TOWN HALL

From: Todd Salter, Manager of Policy, Town of Caledon

Re: **Comprehensive Broader Scale Environmental Study, Caledon Aggregate Resource Area 9-A
Draft Part B Report, Volumes 1 & 2, dated June 29, 2007 and Part B Hydrogeological Modeling Task – Draft
Report June 2007**

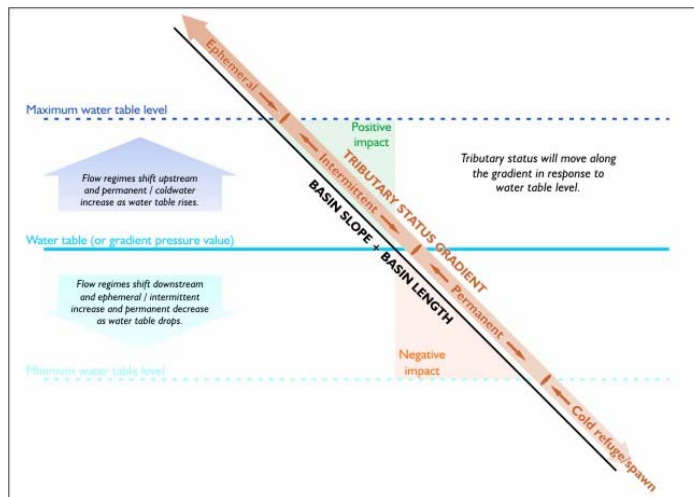
Page 6-24 v) By definition perennial habitats do not have a hydroperiod (of no flow) and any reduction would be significant. Please state that perennial streams would be the most resistant (less sensitive) to changes in hydroperiod given the strength of groundwater baseflows, but the significance of any hydroperiod impacts would be great if it did occur. They remain sensitive to baseflow volume changes that are assessed separately.

By extension, it is later suggested that perennial coldwater are most sensitive to hydroperiod than intermittent reaches. This can be relating water

disputed by a graphical representation table/gradient changes to flow regimes.
